TITLE: **USE PERMIT NO. 139**, requested by Hampton Development Services, for 500,500 sq. ft. of industrial and office uses, with associated waiver requests, on property generally located between North 14th and North 27th Streets, north of I-80 and south of Alvo and Arbor Roads.

LINCOLN/LANCASTER COUNTY PLANNING STAFF REPORT

P.A.S.: Stone Bridge Creek
Annexation No. 00003
Change of Zone # 3265
Special Permit # 1845
Preliminary Plat #00017
Use Permit # 139

Use Permit
STONE BRIDGE CREEK
SITE UTILITY PLAN

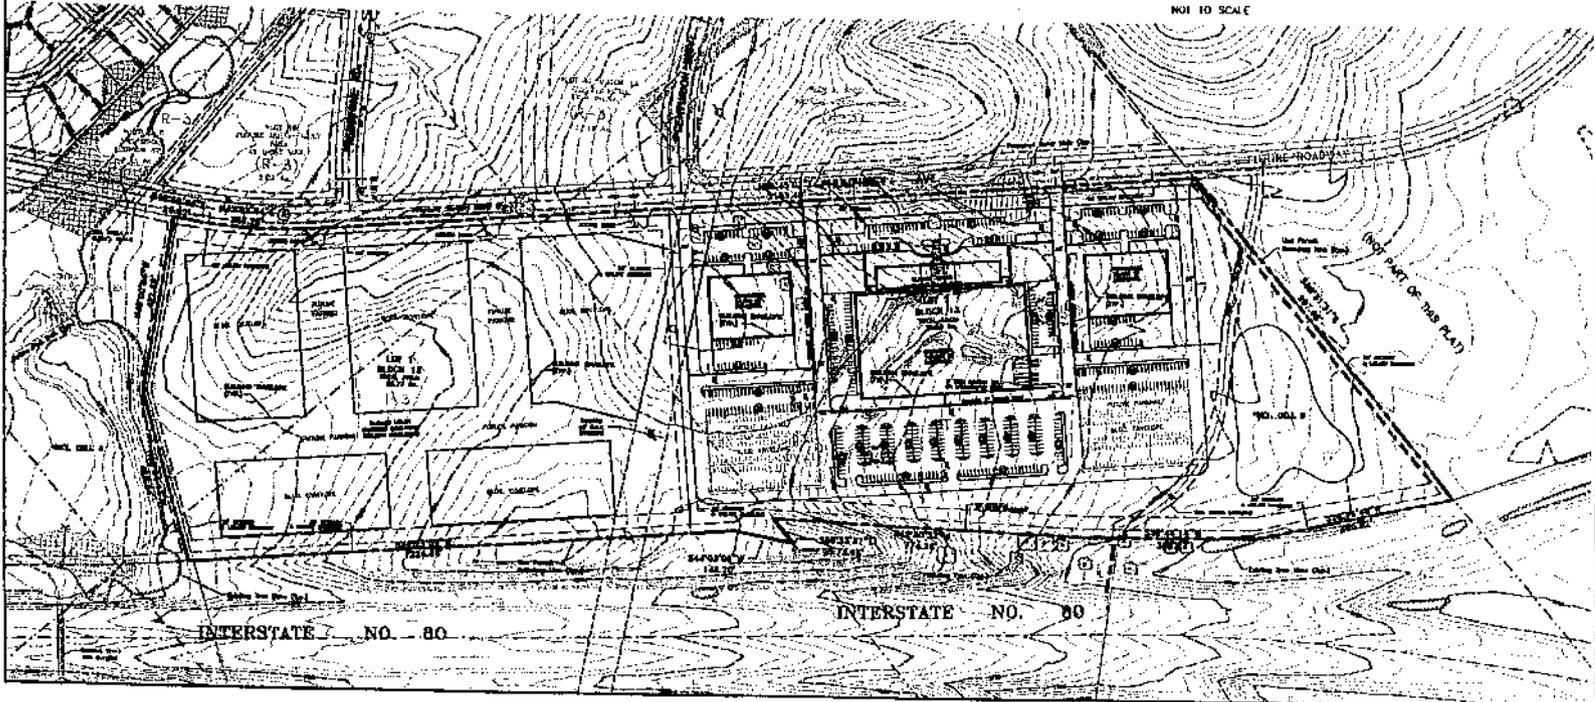
- 1.1 Revise the site plan to show:
 - 1.1.1 The land use parking table to show the same amount of office and industrial square feet as shown on the site plan.

- 1.1.2 Combined notes on sheets 1 and 2 to only one page, the same sheet as the site plan.
 - 1.1.3 Note 12 to read "buildings may be constructed anywhere within the building envelope shown."

- 1.1.4 A landscape plan that removes the street trees from the area of the driveways along Humphrey Ave.
 - 1.1.5 Austrian Pines replaced with a different evergreen species due to serious Pine Tip blight Disease problems.

- 1.1.6 Evergreens in the existing 80' DHE easement. LES needs to determine if they want such materials planted in the easement. Honeylocust and Linden also need to be shown to be planted in the easement.

- 1.1.7 A landscape plan that designates the street tree "Red Sunset Maple" along Humphrey Avenue and planted 40' to 50' on center. No trees should be planted within 15' of either side of the driveways, street lights and from the street intersections.

- 1.1.9 Note 20 to indicate that signs will be in conformance with chapter 27.69 and to indicate that building materials will contain no more than 70% metal siding in conformance with 2751.030(b)(6).

- 1.1.11 A landscape plan with screening trees with a 30' spread.
- 1.1.12 Plans signed and sealed by a licensed surveyor.
- 1.1.13 A Planning Commission approval block to City Council approval block.

- 1.1.14 Revise the trees in the LES transmission easement to the satisfaction of the Parks and Recreation Department and LES.
- 1.1.15 Add a note to the landscape plan that no plant material shall be planted in the utility/pedestrian easements unless approved by LES or the City.

*While being a general statement, the LLCHD is amiable to number 19 of the general site notes for the Stone Bridge Creek Site/Utility Plan which addresses LLCHD's past concerns regarding the manufacture and/or storage of hazardous materials and chemicals adjacent to residential zoning. The LLCHD fully expects the restrictive covenants to be strictly enforced regarding the use, storage, and/or manufacture of hazardous chemicals.
